Proposed Project Description: 17'x9'2" addition and 20'3"x16 addition to existing loading dock		FIRE DEPT. <input checked="" type="checkbox"/> Approved <input type="checkbox"/> Denied Signature: <i>[Signature]</i>		
		INSPECTION: Use Group: <i>S-1</i> Type: <i>000896</i> Signature: <i>[Signature]</i>		
		PEDESTRIAN ACTIVITIES DISTRICT (P.A.D.) Action: <input type="checkbox"/> Approved <input type="checkbox"/> Approved with Conditions <input type="checkbox"/> Denied Signature: _____ Date: _____		
Permit Taken By: K.		Date Applied For: July 19, 1999 K.

BUILDING PERMIT REPORT

REASON FOR PERMIT: Two additions 9'-2" x 17' 6" 16' x 20'-3"

RE: Loading Dock Additions
Hobson's Wharf

NYLE CORPORATION
BANGOR - 9/14/99
MAINE SELECT SEAFOOD
EQUIPMENT ROOM LAYOUT

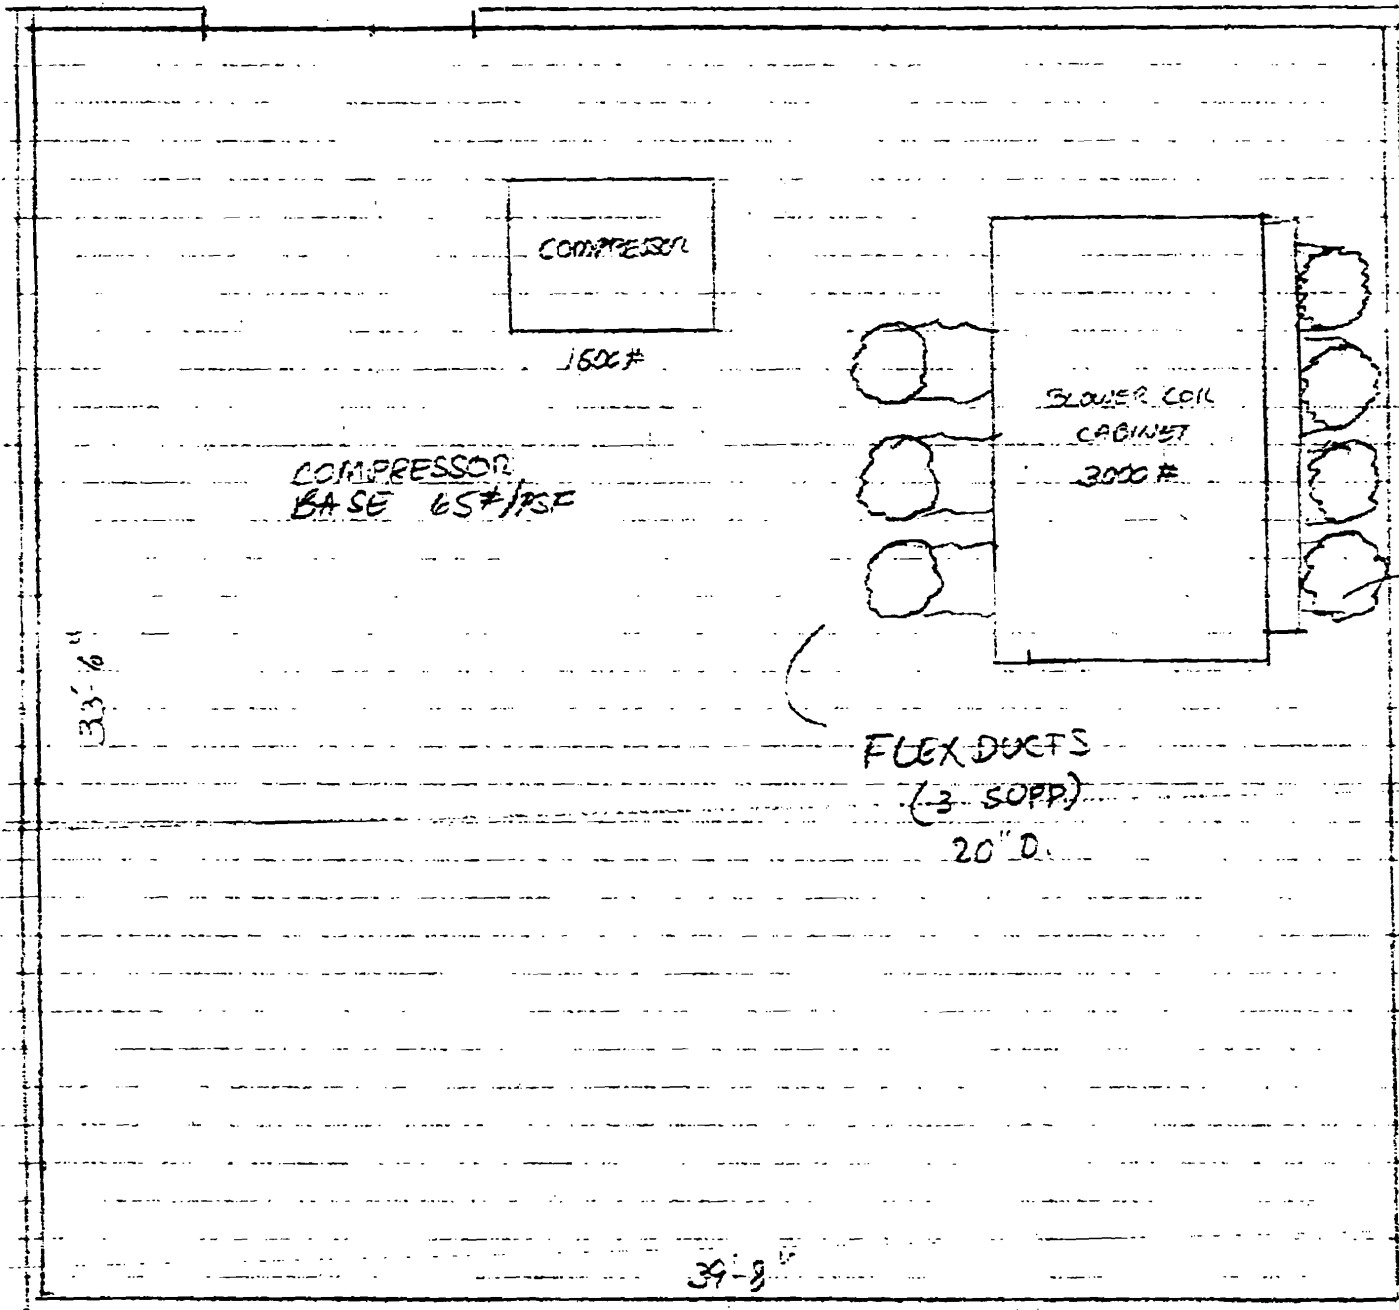
RE: Dryer Unit at
Hobson's Wharf

I have investigated the loading on the second floor of your building at Hobson's Wharf caused by the installation of the dryer and compressor units. Using the information provided to me by Donald Lewis, PE of the Nyle Corporation (enclosed), the floor loads produced by the dryer and compressor are 32.8 psf and 68.1 psf respectively. The 12K5 series steel joists supporting your second floor are capable of supporting a live load of 100 psf with deflection not exceeding 1/240. Accordingly, the floor is of sufficient capacity for the dryer and compressor.

NYLE CORPORATION
 BANOR - 9/14/99
 MAINE SELECT SEAFOOD
 EQUIPMENT ROOM LAYOUT

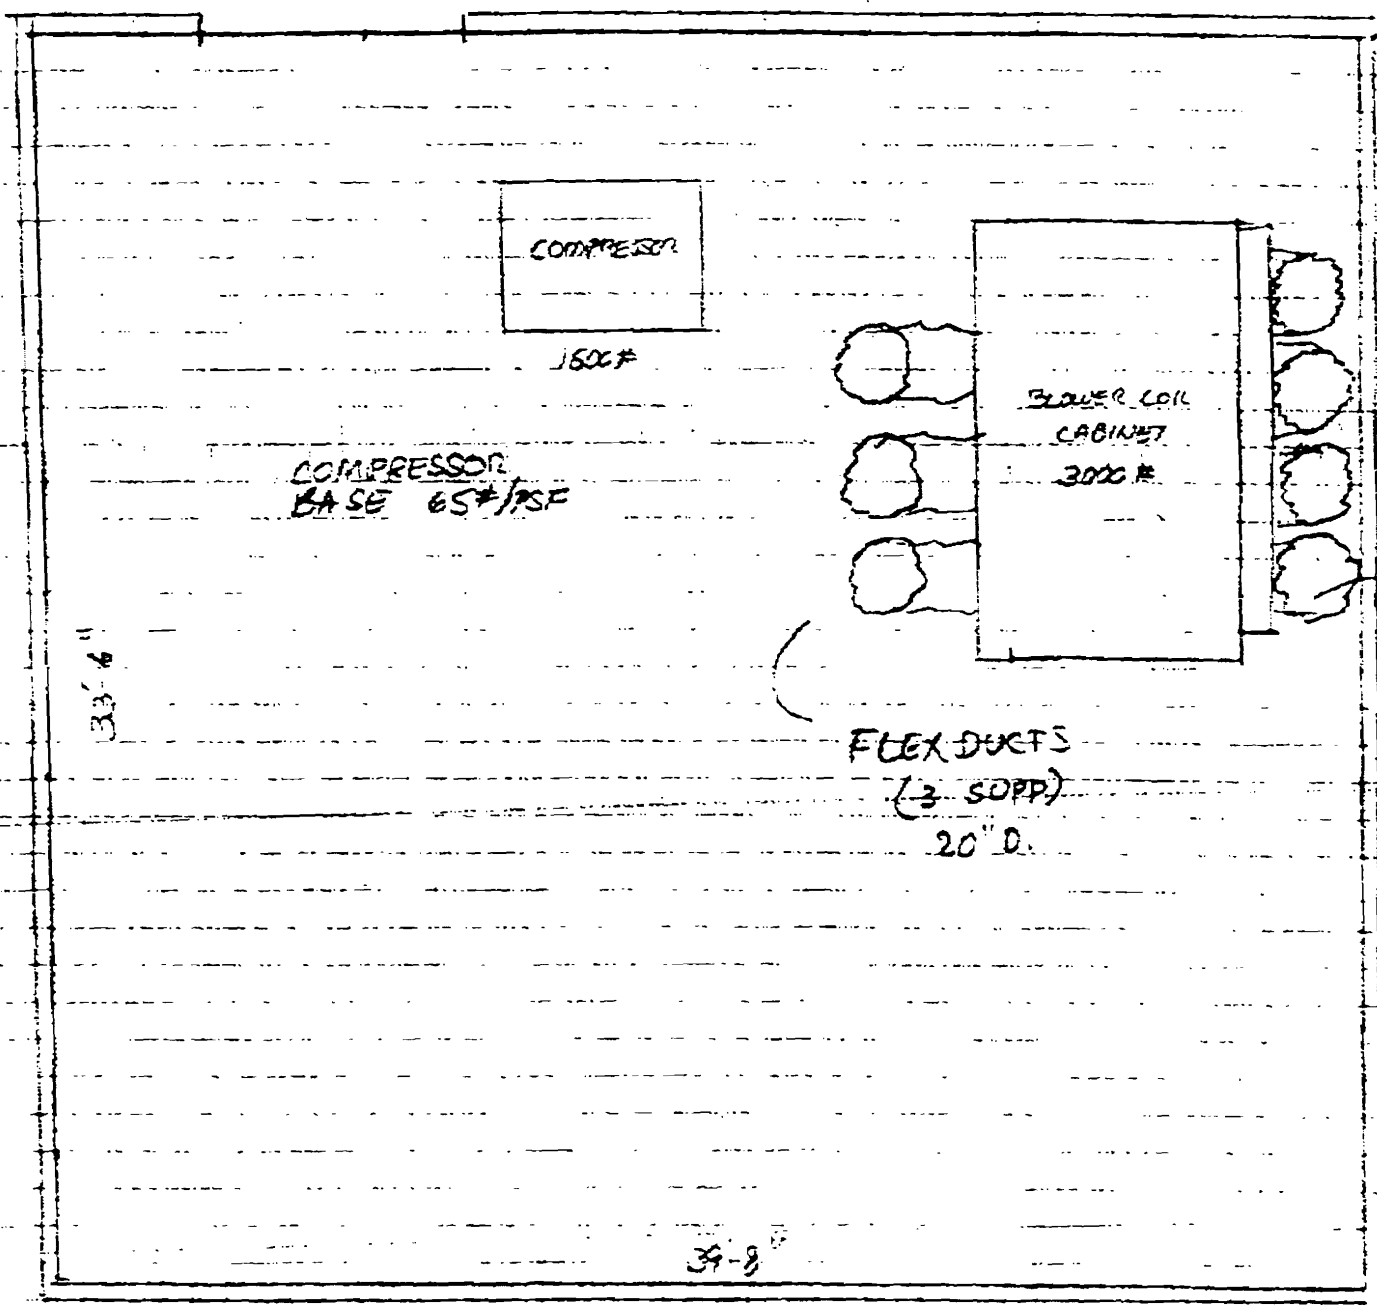
RE: Dryer Unit at
Hobson's Wharf

I have investigated the loading on the second floor of your building at Hobson's Wharf caused by the installation of the dryer and compressor units. Using the information provided to me by Donald Lewis, PE of the Nyle Corporation (enclosed), the floor loads produced by the dryer and compressor are 32.8 psf and 68.1 psf respectively. The 12K5 series steel joists supporting your second floor are capable of supporting a live load of 100 psf with deflection not exceeding 1/240. Accordingly, the floor is of sufficient capacity for the dryer and compressor.

NYLE CORPORATION
 BANGOR - 9/14/95
 MAINE SELECT SEAFOOD
 EQUIPMENT ROOM LAYOUT

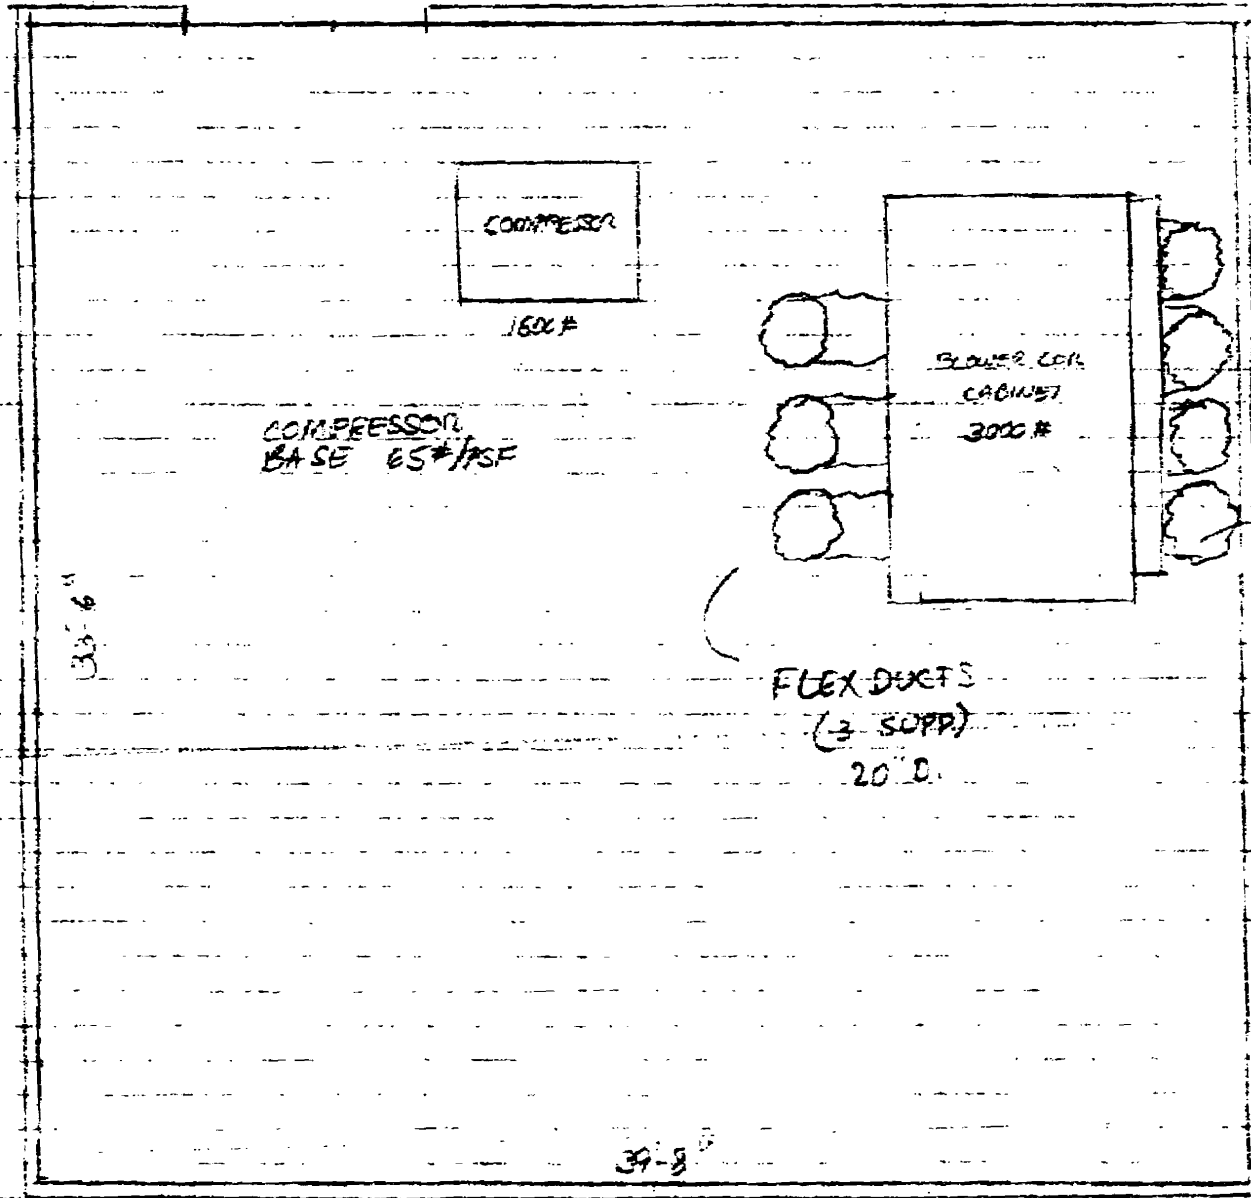
RE: Dryer Unit at
Hobson's Wharf

I have investigated the loading on the second floor of your building at Hobson's Wharf caused by the installation of the dryer and compressor units. Using the information provided to me by Donald Lewis, PE of the Nyle Corporation (enclosed), the floor loads produced by the dryer and compressor are 32.8 psf and 68.1 psf respectively. The 12K5 series steel joists supporting your second floor are capable of supporting a live load of 100 psf with deflection not exceeding 1/240. Accordingly, the floor is of sufficient capacity for the dryer and compressor.

Roof . Black Single on top
2x6 Joist
1/2 inch plywood on top

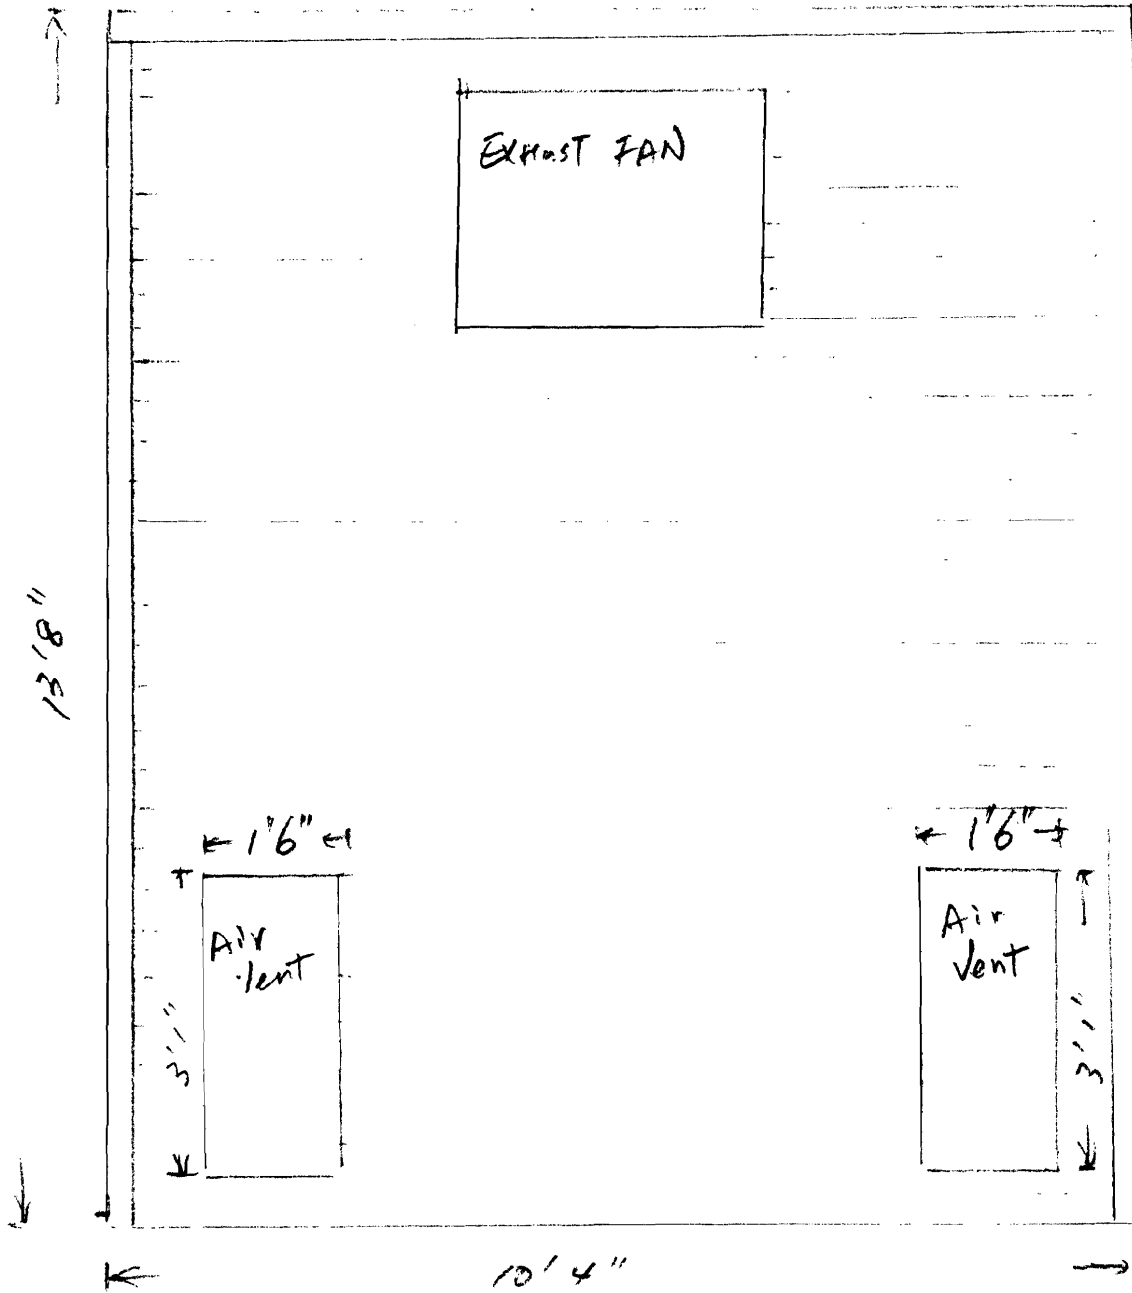
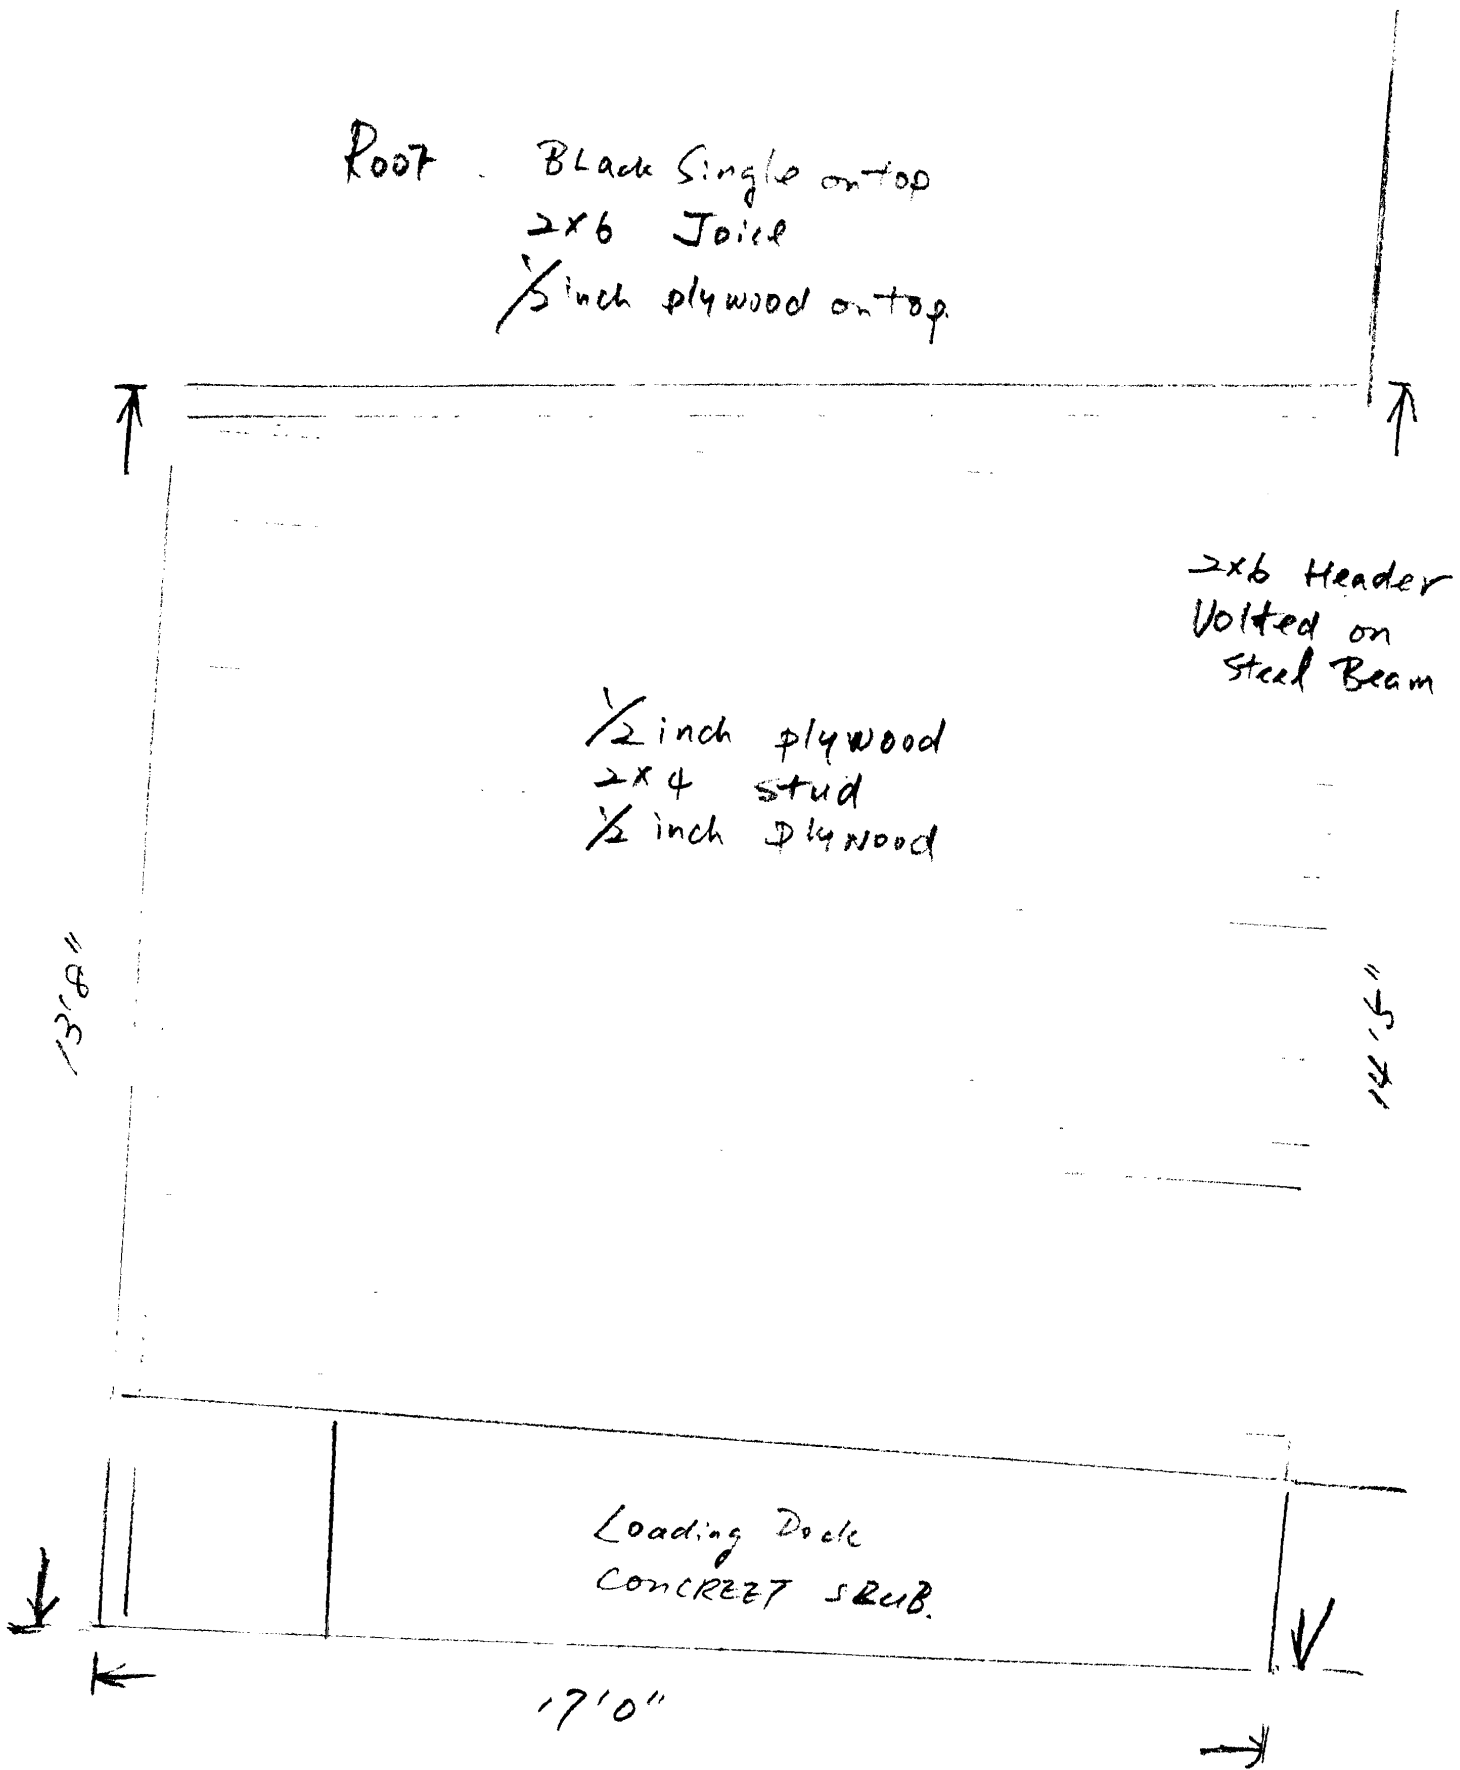
1. Plans call for 2x12 rafters. They are double 2x6's
2. No permit for HVAC equipment
3. Need J.O. involvement regarding fire rating where burners are.
4. Need engineers statement concerning roof as built + HVAC Room. JR

- *33. Glass and glazing shall meet the requirements of Chapter 24 of the building code.
- *34. *The proposed 2x6" rafters (shown on plans as joists) does NOT meet Code requirements. A minimum of 2x12"@12" O.C. shall be required for a 20' span. Please resubmit plans to reflect change before work begins*

I have examined the two loading dock additions you made at Hobson's Wharf. In each of these, the roof rafters are double 2"x 6"'s on center to center spacings up to 2'-4" with spans of 16 and 20 feet. In both of the sheds, these are inadequate for the roof dead loads and snow load.

In the small shed (10'x 16'), two 2"x 6"'s were added at the roof center to shorten the effective span of the roof rafters to 8'. While this results in the roof rafters being adequate, the two 2"x 6"'s must be replaced with two 2"x 12"'s of southern yellow pine or douglas fir. These must be framed to bear on double 2"x 4" studs in the walls which must bear on the floor or bottom sill.

In the large shed (16'x 20'), two 2"x 6"'s were added at the roof center to shorten the effective span of the roof rafters to 10'. Two posts were additionally installed to shorten the effective span of the center roof beam to 7'. While this results in the roof rafters being adequate, the two 2"x 6"'s must be replaced with two 2"x 10"'s of southern yellow pine or douglas fir. These must be framed to bear on double 2"x 4" studs in the walls which must bear on the floor or bottom sill. I would also advise that you install knee braces between the roof beam and the posts at midspan. Alternatively, you could replace the 2"x 6"'s with one 8"x 12" and eliminate the intermediate posts.
